## Planning Commission - Public Comment for April 14, 2022 Agenda Item #4: 22-0616

PC 04-14-2022

# **GV Early Release Kinder-5th**

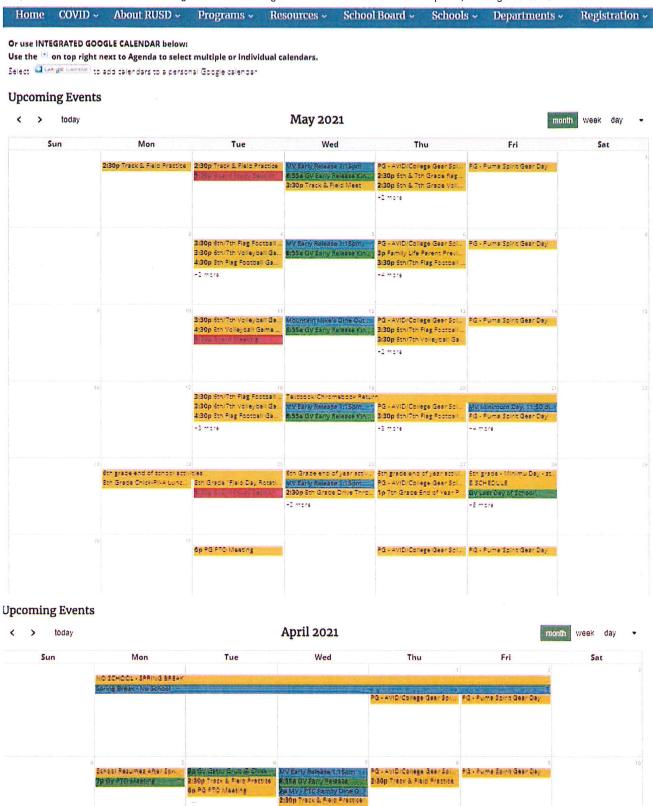
PLEASE SEE THE snipets from the Rescue Union School District webpage below - you will see that during the weeks of April 1 - May 22, every Wednesday the Green Valley Elementary School was on early release schedule for K-5<sup>th</sup> grade. This is basically the entire school getting out early and many parents probably drove back and forth on Green Valley Rd to pick up students. While this data could be valid in showing actual changed traffic patterns - the numbers of vehicle trips would simply shift sooner during the day from the regular

However, depending on the students involved for each family could be making two trips if they had a TK child enrolled, the Kimley-Horn study for turning movement avoided such data because they moved the "Intersection Turning Movement Count" to 5-26-2021.

May 26th was the first Wednesday during the Green Valley School schedule wherein they did not have an Early Release day, and the last day of school was May 28th.

Kimley-Horn does not address a reason to not reflect the Intersection Turning Movement Count on the same day actual counts were performed on May 12th, as it should have been.
